RE: Resurgence Brewery & Rock Gym
DCI2022-00019
Haley Ward Project Number 2011255.001(21-59)

Enclosed herewith for your review and approval are our response letter, various attachments, and the revised Master Concept Plan for the above referenced project. Moreover, the following are chronological responses to the various staff comments as listed in your sufficiency letter dated July 25th, 2022:

Mr. Adam V. Mendez, Lee Co. | 2nd Sufficiency Response | 10.21.2022 | 2011255.001(21-59)

MASTER
CONCEPT
PLAN

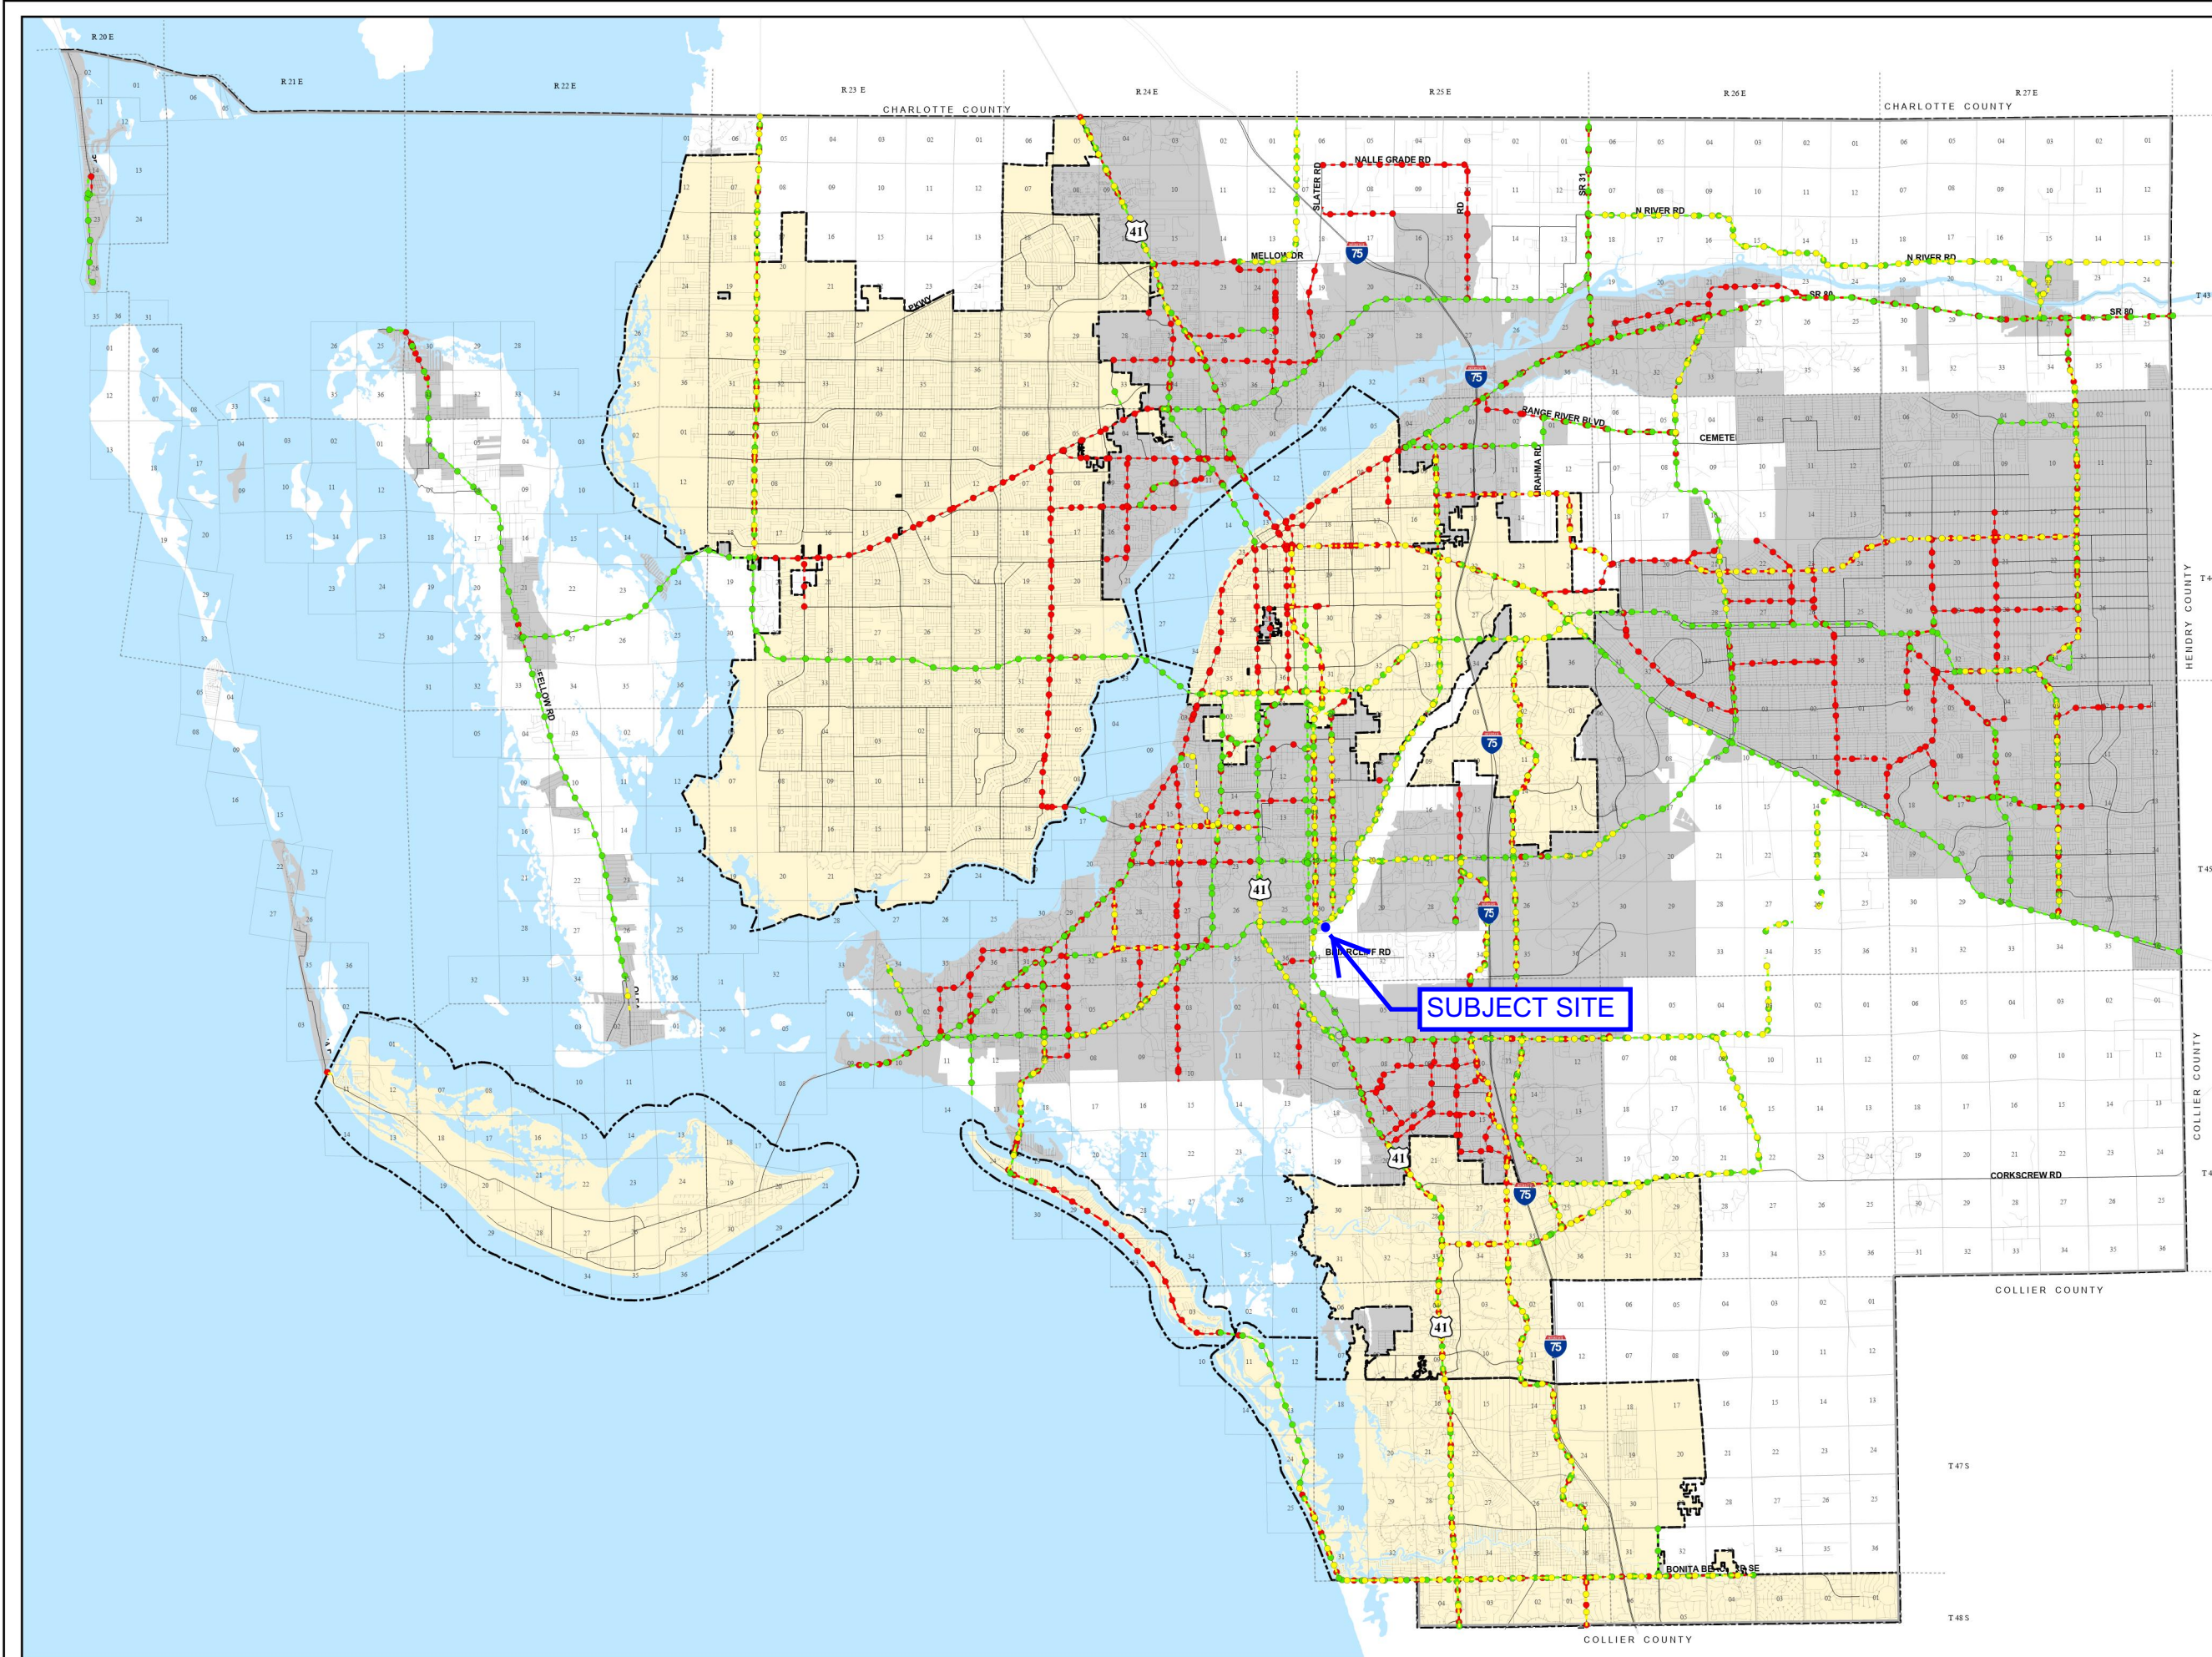
Comment 1. Please be advised that the Zoning Review for the subject case has been found sufficient. In response to recent direction provided by the Lee County Hearing Examiner's Office, staff offers the following courtesy comment.

- A. *Consider removing development order details and information not explicitly required on a Zoning Master Concept Plan. The requirements are listed in **LDC Section 34-373(a)(6)**. Staff recommends that the Schedule of Uses, Property Development Regulations and Parking Note are to be provided separate from the MCP, to avoid future revisions to the MCP as this content may change.*

Response 1. See the attached revised Master Concept Plan for the above requirement. The removed information is submitted herewith on separate sheets.

Lee Plan Map 3-D

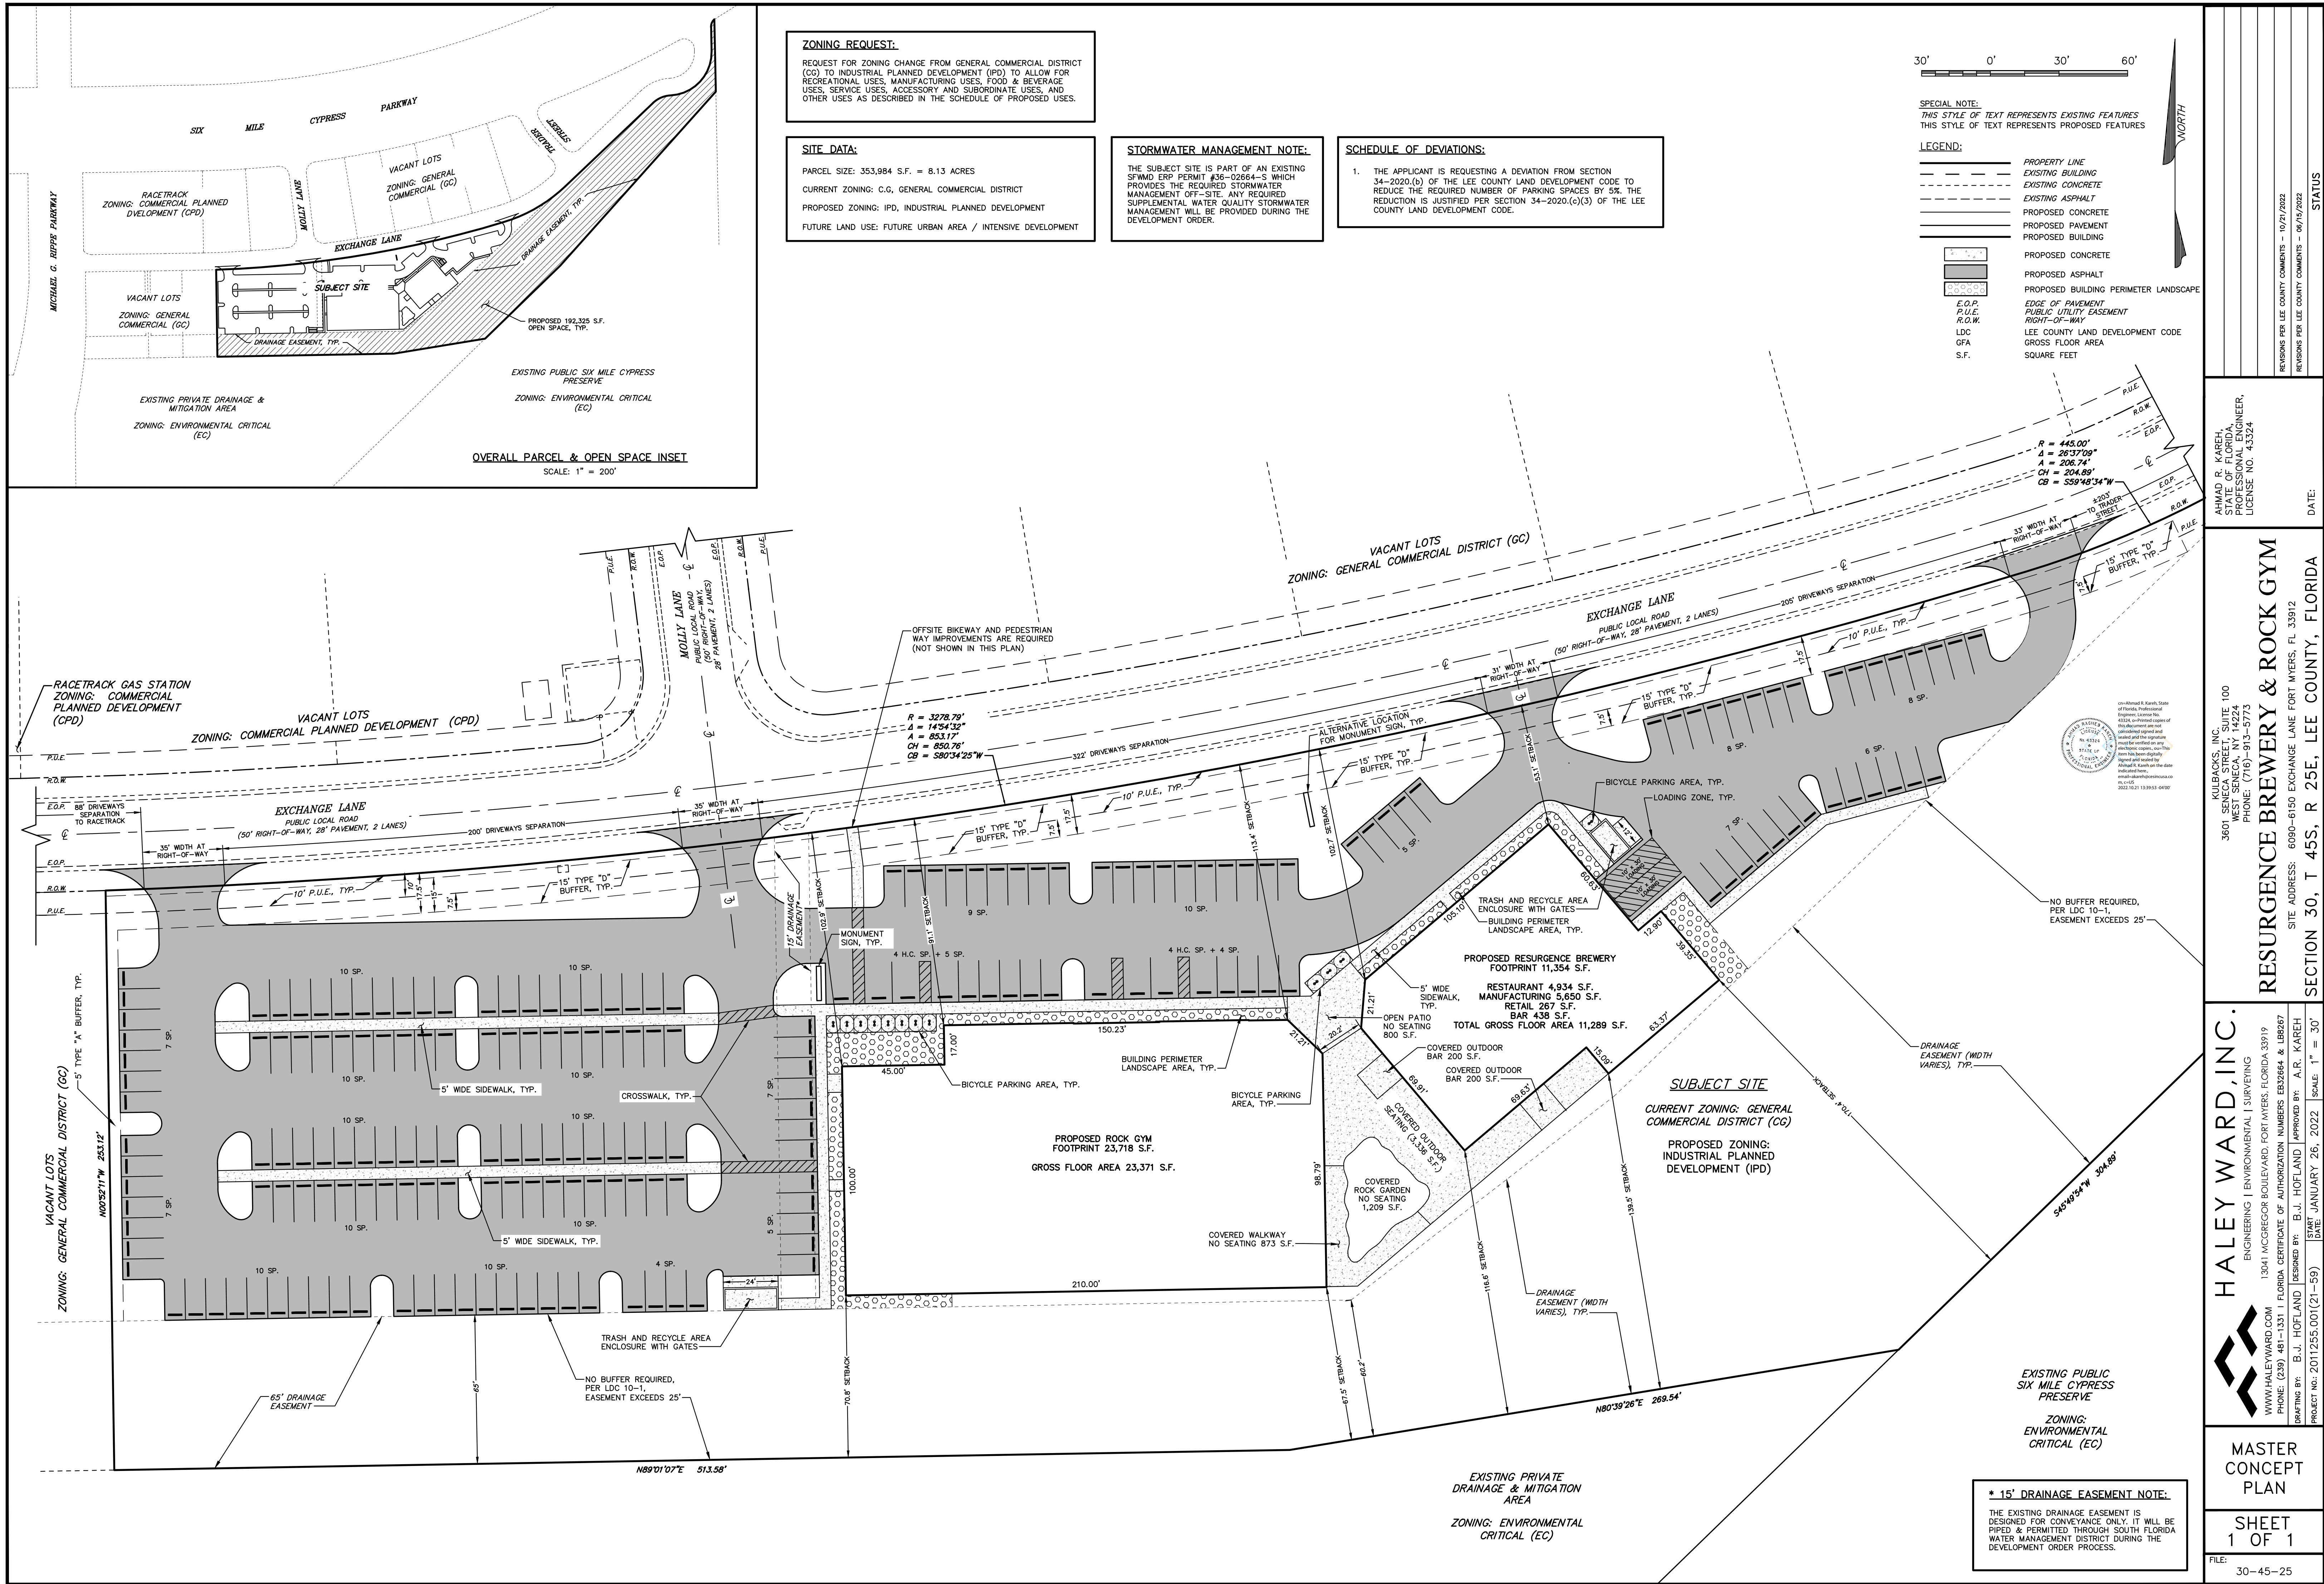
Comment 1. Staff does not support deviation (1), as proposed. The applicant's MCP and justification indicates that they are seeking a 10% reduction in parking due to the "complimentary nature of the proposed uses". However the parking calculations on the MCP use the minimum parking required for Multi-Use Developments and further seeks a reduction for "complimentary uses". The purpose of the Multi-Use calculation in LDC 34-2020(b) is to account for the reduced parking requirements that result from multiple complimentary uses and therefore the applicant has already realized a reduced parking requirement. Staff does not agree that a further reduction for "complimentary uses" is reasonable. LDC 34-2020(c) lists specific requirements for parking reductions for non-residential uses. Although the applicant's justification references (1) transit stops and (3) bicycle and pedestrian facilities the justification presented does not demonstrate that those requirements have been met. Please review the requirements in LDC 34-2020(c)(1 and 3) and demonstrate that the minimum requirements are met.

- A. THE SUBJECT SITE IS ADJACENT TO THE EXISTING SHARED USE PATH ALONG SIX MILE CYPRESS PARKWAY. SEE ATTACHED LEE PLAN MAP 3-D.
- B. ON-SITE SIDEWALKS ARE PROPOSED FROM THE ON-SITE USES TO THE EXCHANGE LANE RIGHT-OF-WAY AS SHOWN IN THE MASTER CONCEPT PLAN.
- C. OFF-SITE SIDEWALKS WILL BE PROVIDED DURING THE DEVELOPMENT ORDER ALONG EXCHANGE LANE AND MOLLY LANE TO CONNECT TO THE SHARED USE PATH ALONG SIX MILE CYPRESS PARKWAY.
- D. BICYCLE RACKS ARE PROVIDED ON-SITE AND ARE SHOWN ON THE MASTER CONCEPT PLAN.
